Traffic Control Plan for

Craftsbury BO 1449 (34)

February 25th, 2016

Vermont Agency of Transportation
RECEIVED
Traffic Plan Rev-1 Resub 3-24-2016.pdf
CK'D BY S. Hisman/A. Gammell OK'D BY WDL
February 25, 2016
RESUBMIT YES Rejected
BY RSY DATE 3-24-2016

PHASE I SK-1

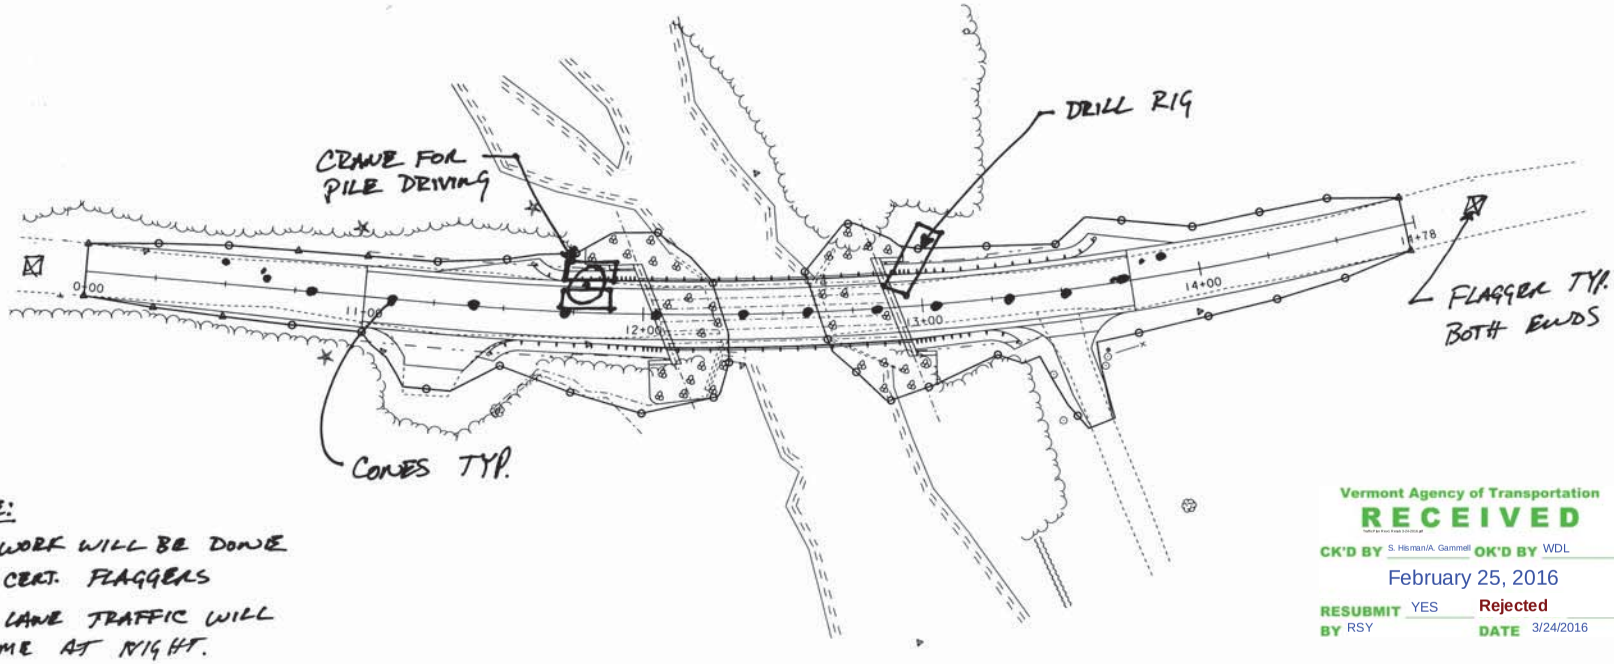
Typical all phases:
_Please show locations and dimensions to all proposed temporary traffic control devices (signs and spacing, cones/barrels spacing and taper lengths, and temporary lane widths). Keep in mind sight distances.
_Please address how access is being managed at the two access points at approximately 11+25 RT and 13+50 RT.
